EFNA Steering Committee

Meeting Summary

Lacy Road

Fitchburg Community Center to S. Syene Road

PROJECT NO:5849-00-09	HWY:LACY ROAD	COUNTY:DANE	PRELIMINARY IMPACTS	PAGE 3

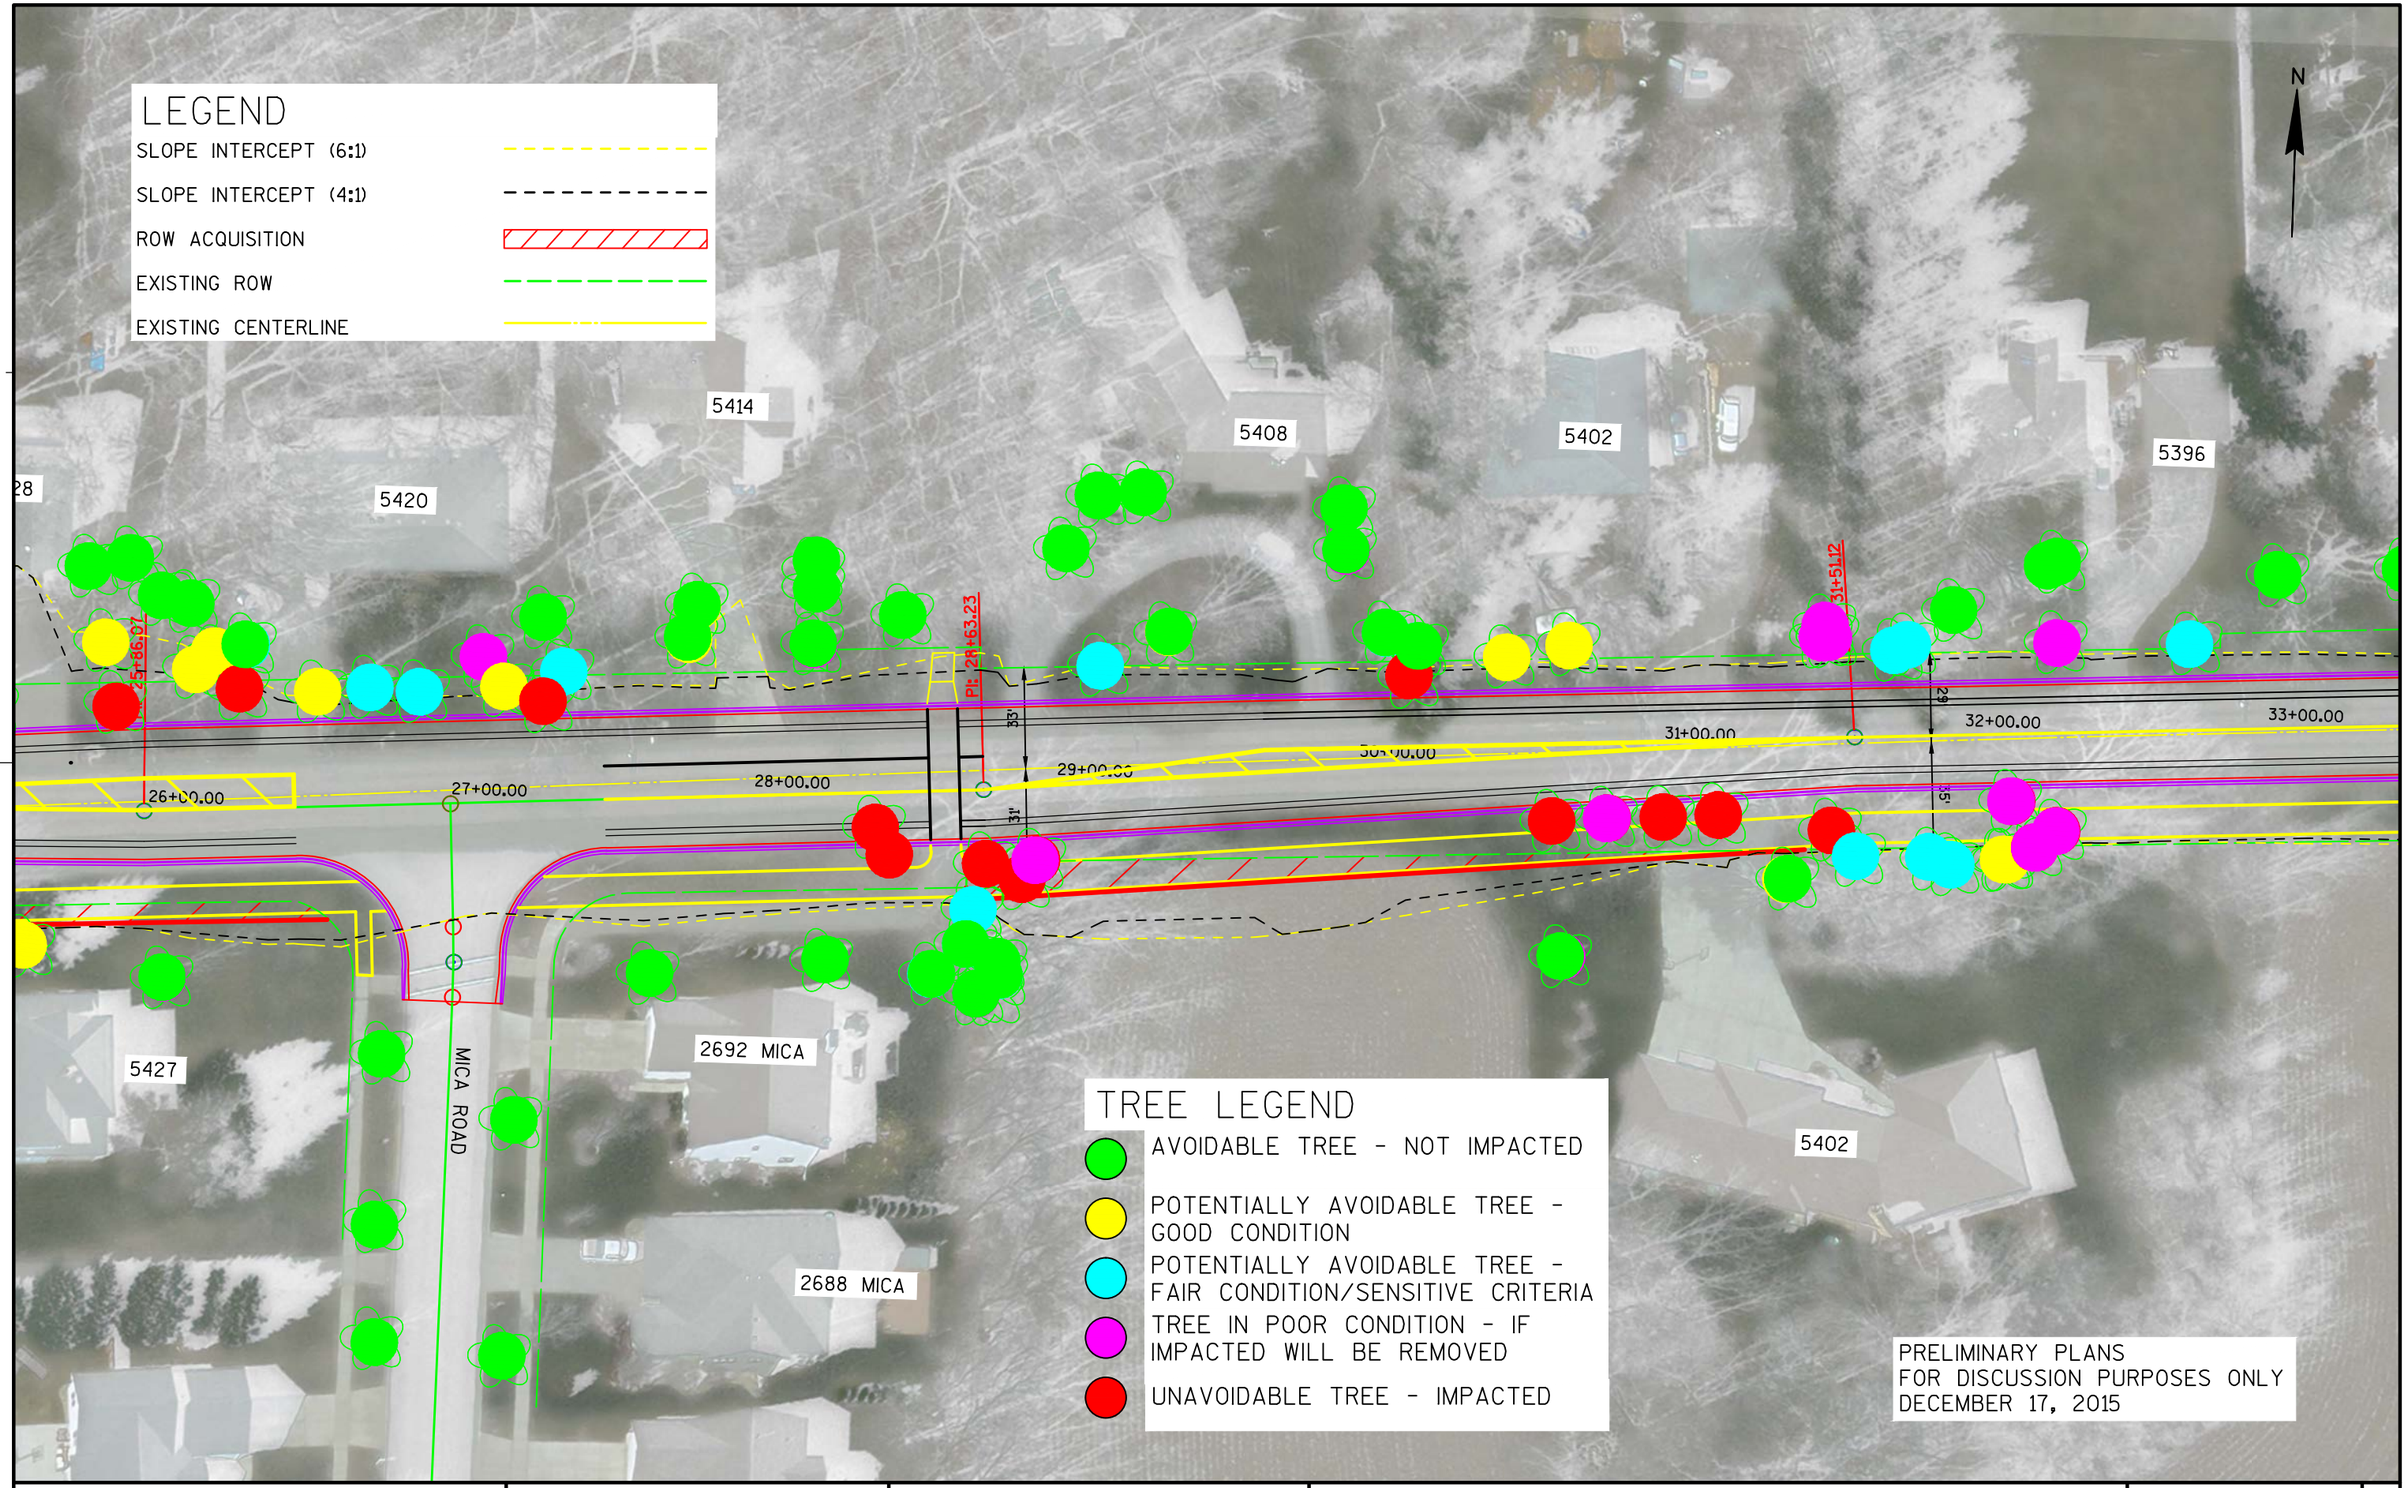
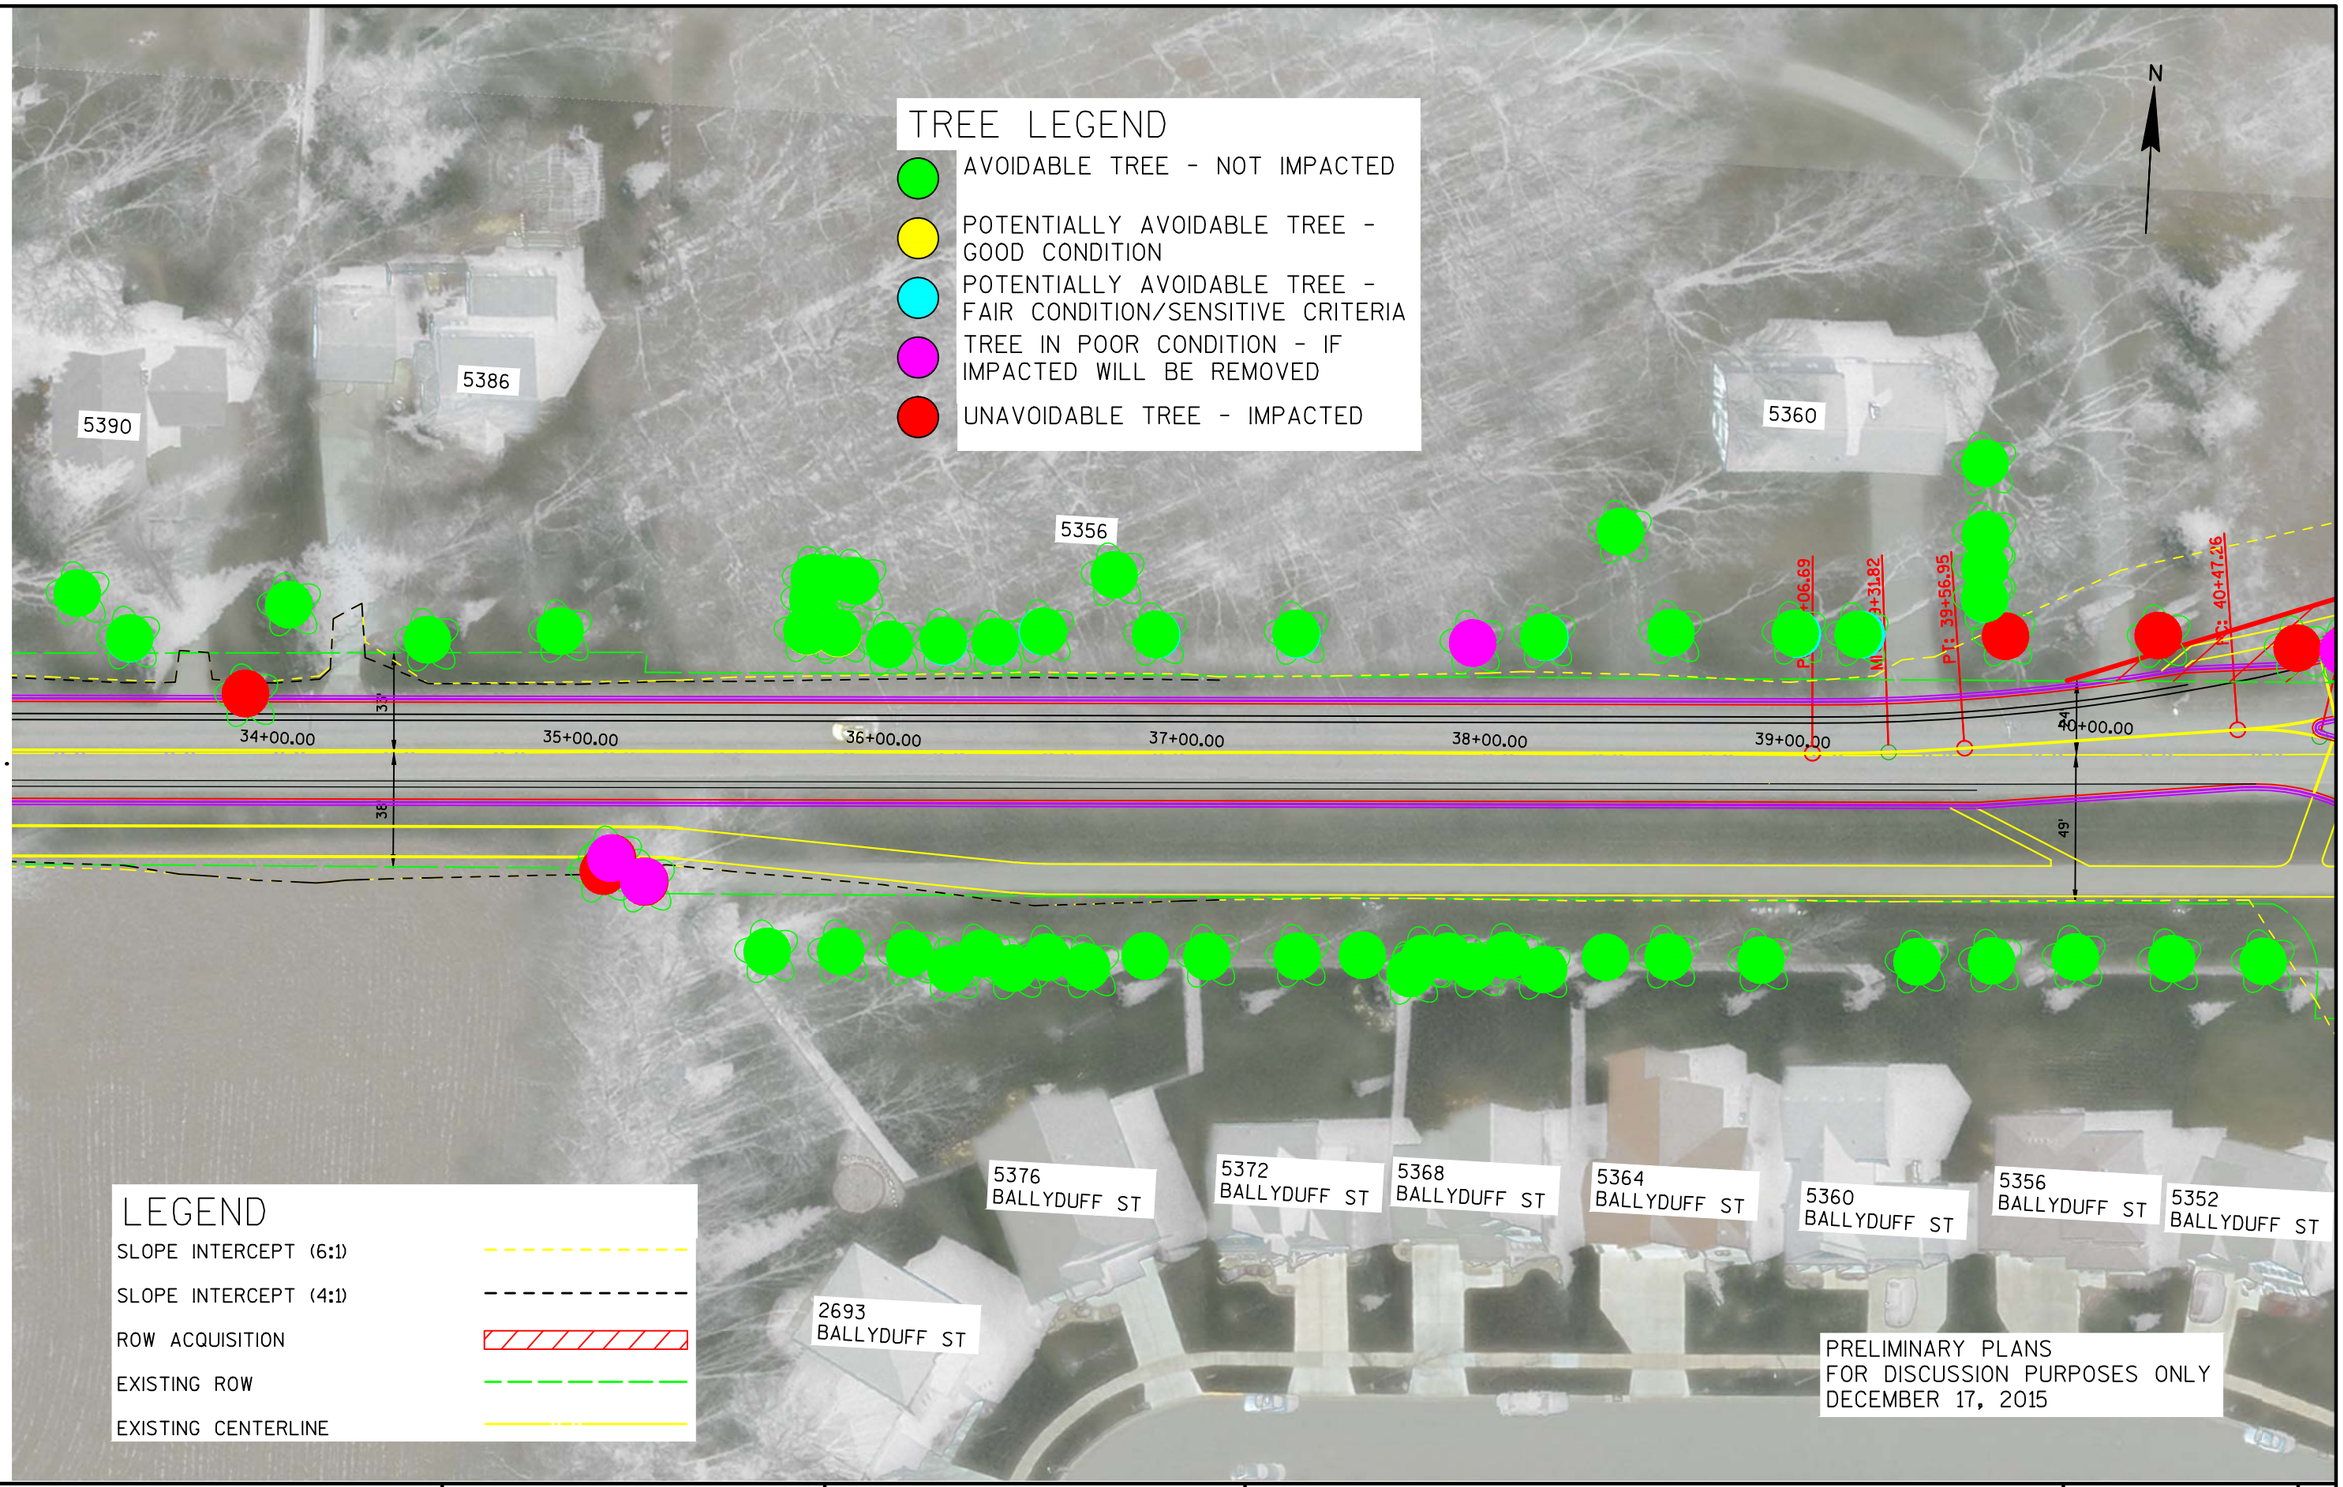
4. Tree evaluation update – Troy provided plans that show each tree along the road. The trees were color-coded to identify "avoidable tree", "potentially avoidable – good condition", "potentially avoidable – fair condition", "potentially avoidable – poor condition", and "unavoidable tree – impacted". These drawings are hot off the press – so additional analysis has not been completed to determine what adjustments would be made to the alignment, terrace width, or path width to potentially avoid tree removals. That is one of the next steps with the design.
